| TYPE | YEAR | PROJECT NO. | SHEET NO. |
|---|---|---|---|
| R.O.W. | 2015 | HSIP-106(33) | 17 |
| CONST. | 2017 | HSIP-106(33) | 27 |

S.R. 106 WILLIAMSON CO.

BEGIN STA. 106+00.00
END STA. 107+00.00

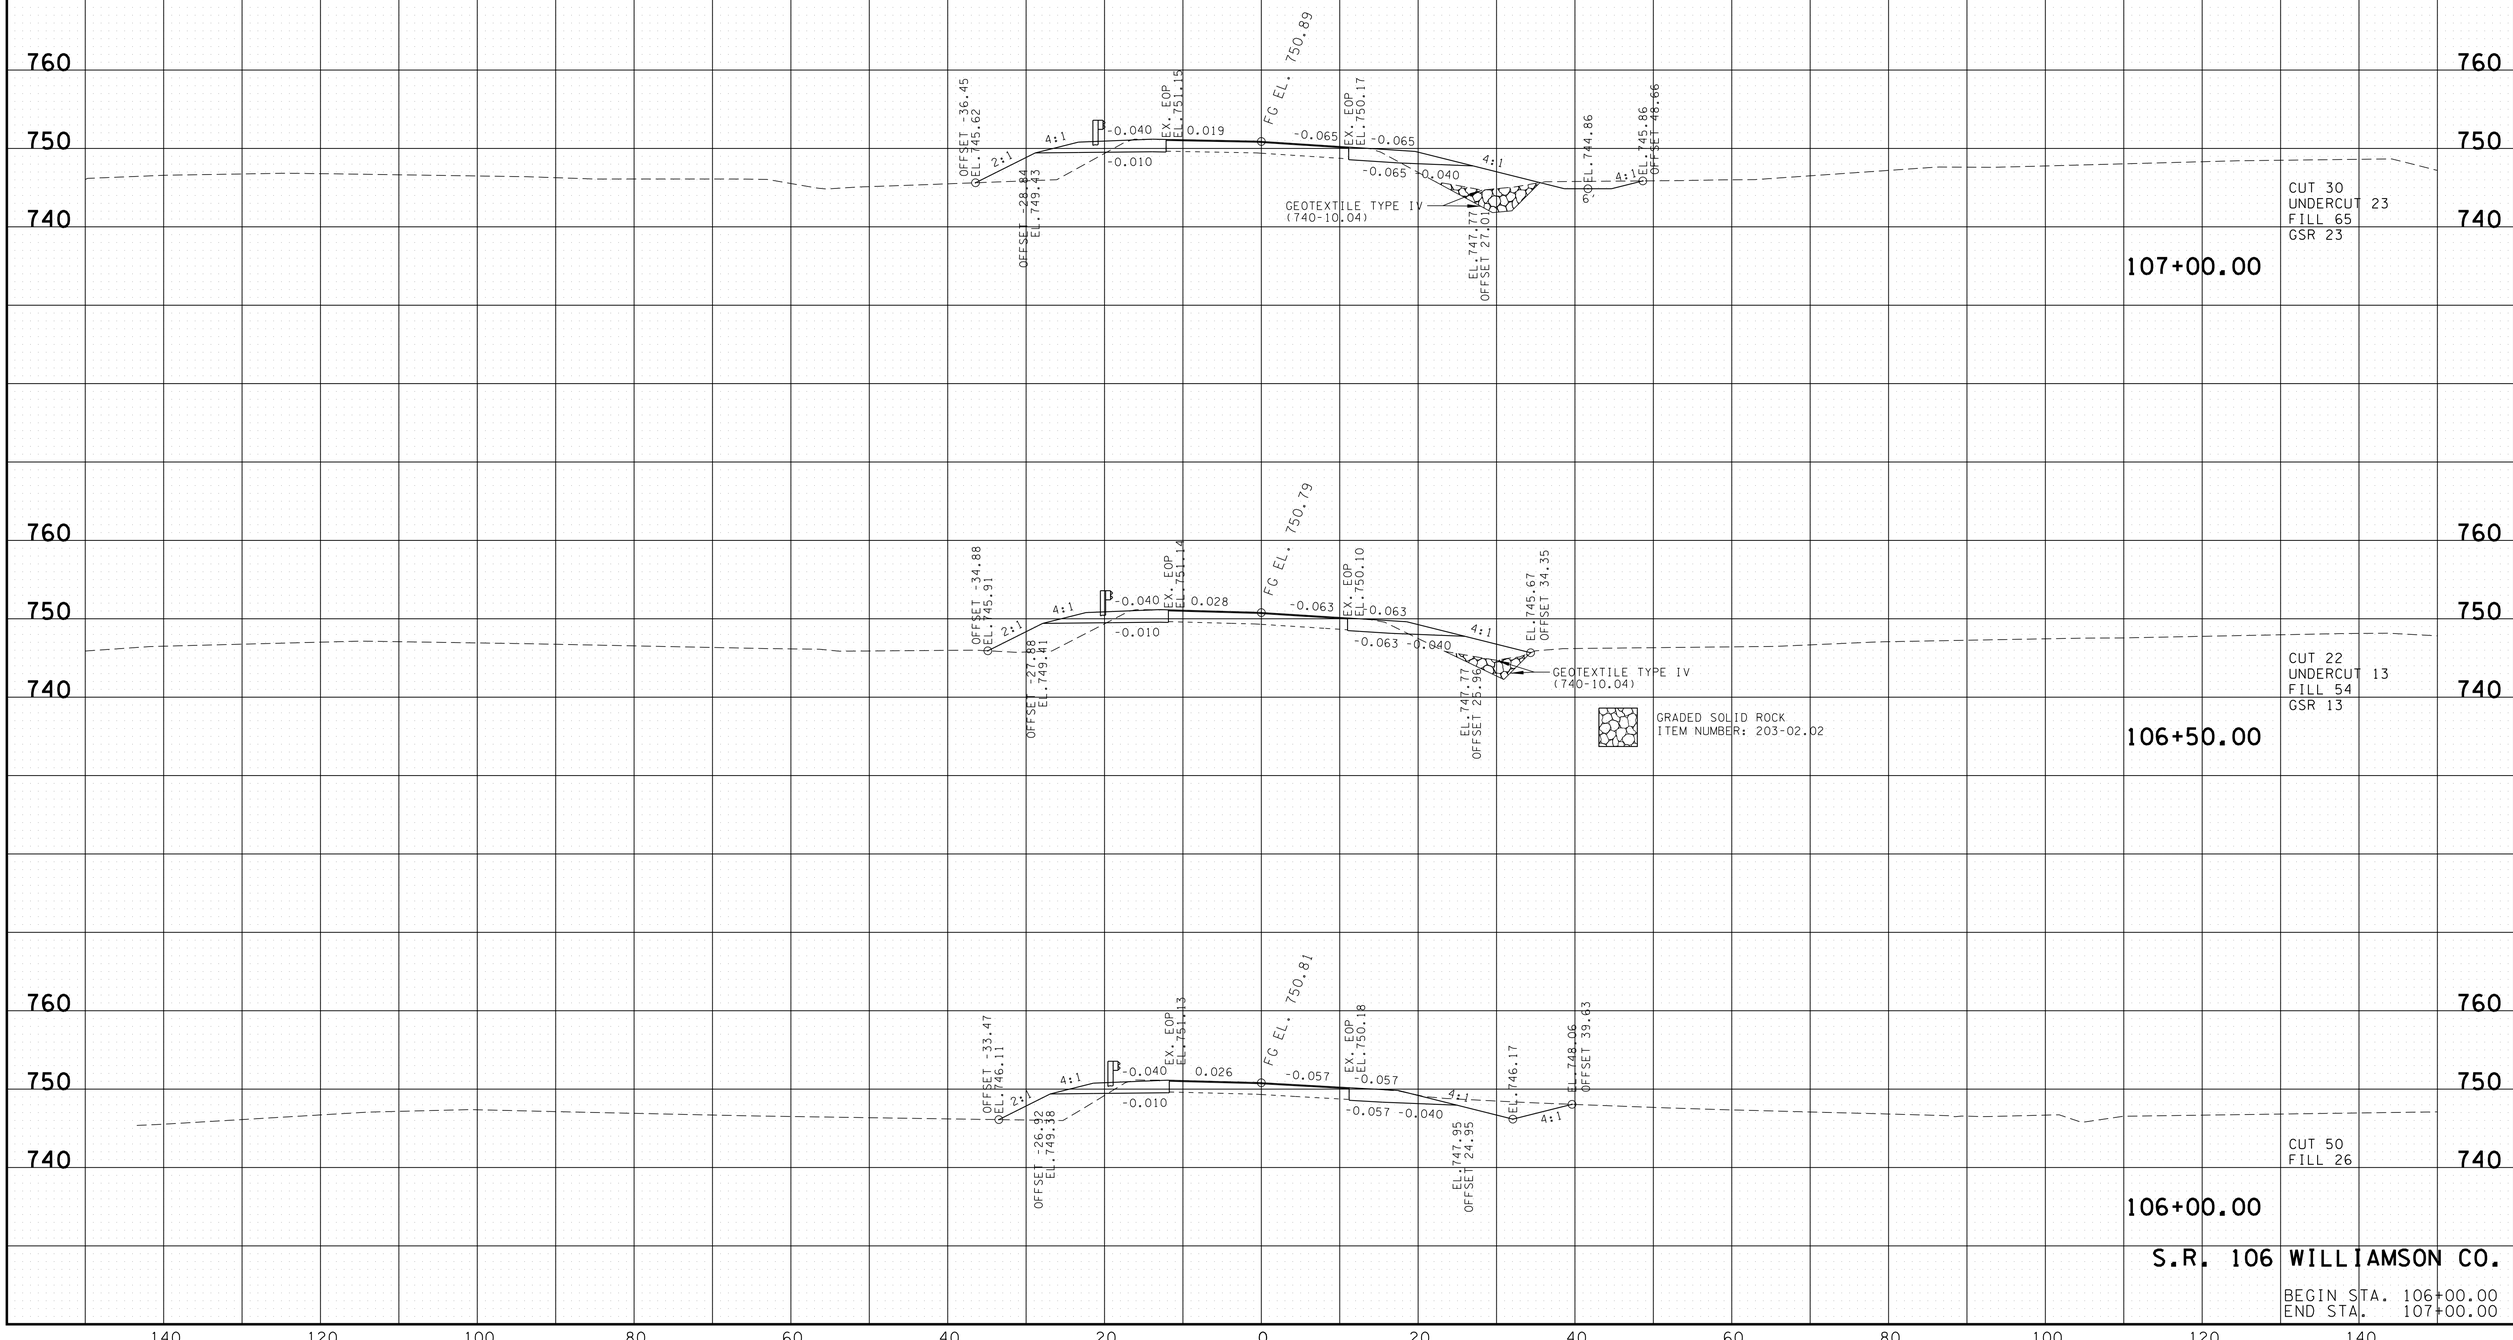
REV. 12-08-16: REMOVED GUARDRAIL, MODIFIED DITCHES, FLATTENED SIDESLOPE FROM 2:1 TO 4:1, AND UPDATED EARTHWORK FROM RT. STA. 106+00 TO STA. 118+50.

STA. 106+35 TO 111+00
MINIMUM UNDERCUT OF 3' REQUIRED PRIOR TO PLACEMENT OF GRADED SOLID ROCK. GRADED SOLID ROCK FILL TO BE WRAPPED IN GEOTEXTILE FABRIC (TYPE IV). SEE GEOTECHNICAL REPORT FOR MORE INFO.
